DOCUMENT CHANGE REQUEST

DCR number 164	Changes required for: General	Originator: Steve Thacker
Date: 2005/11/02	Date sent: 2005/11/02	Organisation: ESA/ESTEC
Status: IMPLEMENTED

Title:	Attenuator, RF Coaxial, Type SMA, DC-22GHz		
Number:	3403/005	Issue:	1

ESCC Detail Specification No. 3403/005

1.6 PHYSICAL DIMENSIONS

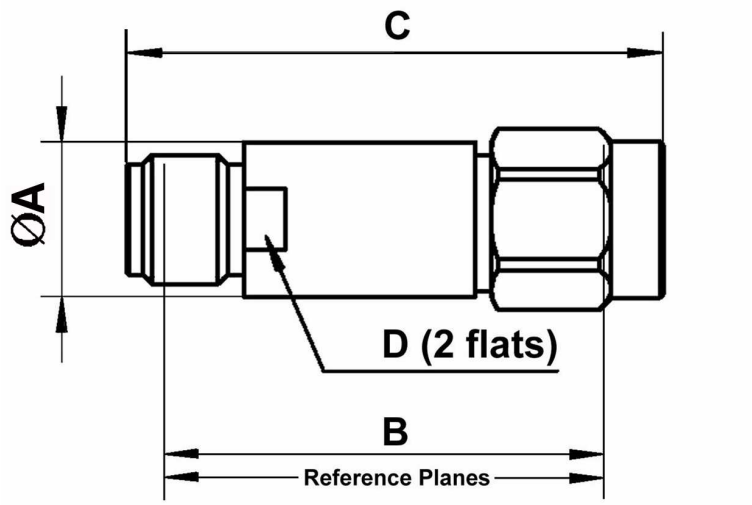
10. Figure 2 Physical dimensions: drawing amended to only include critical dimensions (Dim's D E F G are deleted). Reference to 3402/003 deleted and interface dimension drawings added (male & female).
